QUALITY ASSURANCE -- NON-CONFORMANCE REPORT

Report No: NCR-000391

Welding	Concrete	Other	
Welding	Curing	Procedural	Bridge No: 34-0006
Joint fit-up	Coating	Other	Component: OBG Floorbeam in Segment 10CE
Procedural	Procedural	Description: Floorbeam FL3 Location (FB020-005)

Job Name: SAS Superstructure

Welding Concrete Other
 Welding Curing Procedural **Bridge No:** 34-0006
 Joint fit-up Coating Other **Component:** OBG Floorbeam in Segment 10CE
 Procedural **Description:** Floorbeam FL3 Location (FB020-005)

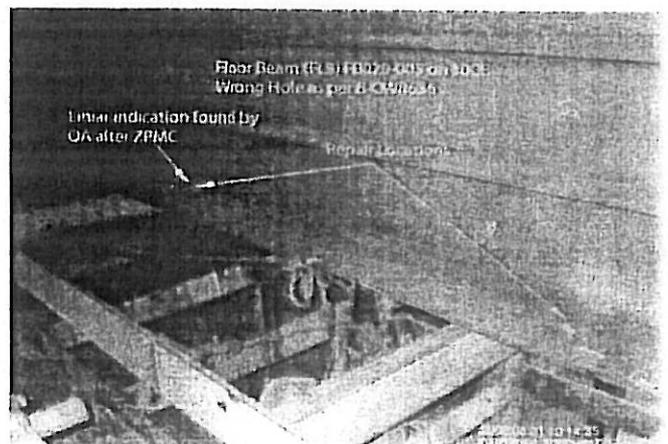
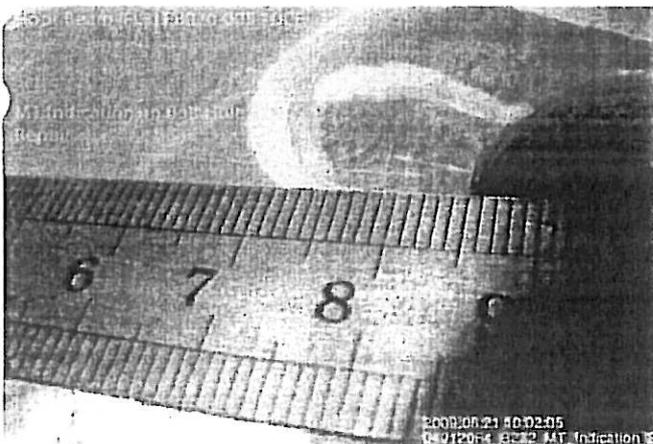
During random verification Magnetic Particle Testing (MT) of the mis-drilled hole repair area on OBG Floor Beam FB020-005 (FL3) on 10CE, Caltrans Quality Assurance (QA) Inspector discovered one (1) linear indication after ZPMC performed MT inspection. Furthermore, QA inspector received notification for inspection after the repair area has been drilled; therefore, proper Ultrasonic Testing (UT) cannot be performed by the QA inspector. This is a deviation from the procedures stated in the Critical Weld Repair B-CWR636 because: 1) VT, UT, and MT need to be performed after the repair; 2) Using plug weld for the mis-drilled hole repair instead of the described WPS; 3) There is an MT indication next to the newly drilled hole.

Remove indication by grinding.

Indication was removed by grinding. Magnetic Particle Testing was performed to verify the indication was removed completely.
